Approval of Reserved Matters Consultation

Application Number: 253071

Site Address: Land To West Of Park Lane, Charvil, RG10 9TS

MEMORANDUM

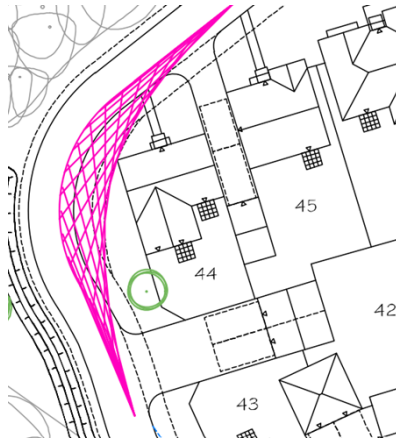
3. The LHA require submission of a drawing which demonstrates suitable visibility around all bends on site. Forward visibility only appears to be demonstrated outside plot 44.

4. The LHA require amendment of the building line outside Plot 44. The sightline passes very close to the building and if OS mapping is inaccurate or the building footprint varies slightly there will not be suitable forward visibility. The LHA also request that the footway outside Plot 44 is widened to allow the forward visibility displayed. This is to ensure the land will not be private and include obstructions to visibility in future such as fences or trees/hedges planted in future.
 - a. **19.06.2026:** This point no longer needs to be addressed given the updated site layout does not include the bend previously shown.

- a. **19.06.2026:** This point is considered addressed. Drawing No. ITS210467-GA-002-Rev-F 'Site Layout Review – Visibility, dated 29.10.25'. Suitable forward visibility has been demonstrated across the site in accordance with the 20mph Design Speed required by the Wokingham Living Streets Guidance.

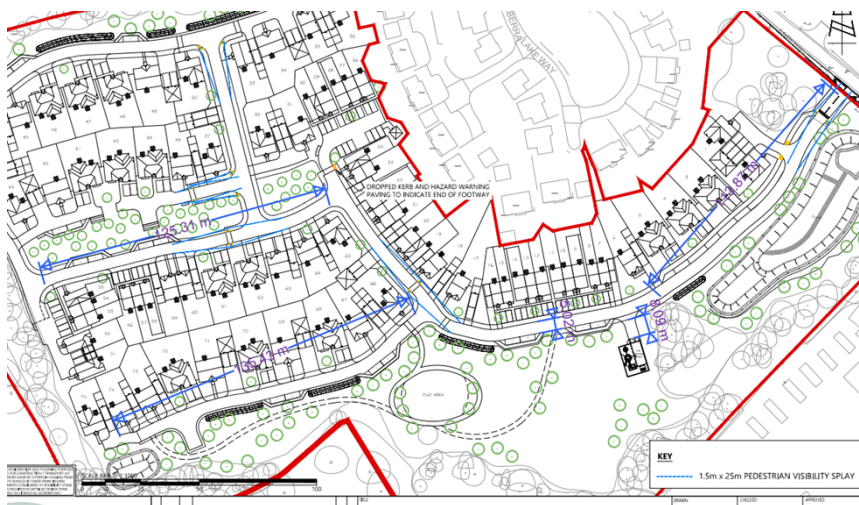
6. Tabled crossings would be welcomed in locations where crossings are needed. An additional uncontrolled crossing should be provided to the play area where a path is shown between the visitor parking spaces:

- a. **19.06.2026:** The LHA consider this point addressed. Crossings are now incorporated into raised tables.

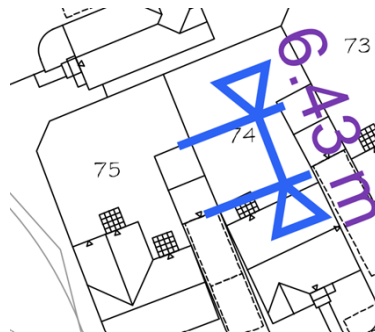
18. The LHA require parking spaces (and garage) outside numerous plots to be pulled further forwards closer to the carriageway. This includes Plot 6, Plot 7, Plot 42, Plot 43, Plot 44, Plot 49, Plot 64, 65, Plot 66, Plot 67, Plot 69, Plot 71, Plot 73 and Plot 74.

19. These dwellings appear to have excess driveway space between their parking spaces and the proposed carriageway; which could result in residents attempting to squeeze in additional parked cars and could result in parked cars overhanging the footway.

20. Otherwise, there is space in front of spaces which could result in use as informal parking spaces (but may not be large enough for a car) and this could result in vehicles overhanging the footway and encourage higher levels of car ownership/parking.

21. Some examples are provided below:

a. **19.06.26:** The LHA are satisfied that this point is addressed by the applicant.
